**E5270A-01**

# **S E R V I C E N O T E**

## E5270A 8 Slot Parametric Measurement Mainframe

### SMU Modules may be Intermittently Unrecognized

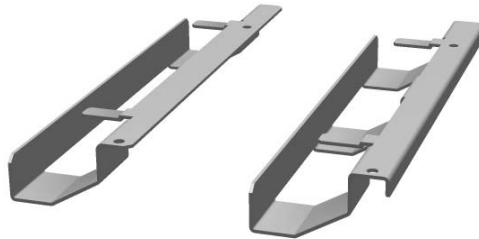
The E5270A within the listed serial number range may have the problem that the installed SMU modules are intermittently unrecognized by CPU board (5270A). Typically, this problem disappears if you uninstall and reinstall the SMU modules.

When you repair or calibrate the E5270A, check the serial number, manufacturing date code (MDC) labeled on the SMU modules, and power supply cable guide.

The improved SMU module has the MDC of 4307 or below as shown below. If the MDC is 4306 or above, replace the SMU front panel with improved one (p/n E5280-00201 and p/n E5281-00201).

The following figure shows the defective cable guide and improved cable guide. If the cable guide is defective one, replace the cable guide with improved one (p/n E5270-01203).
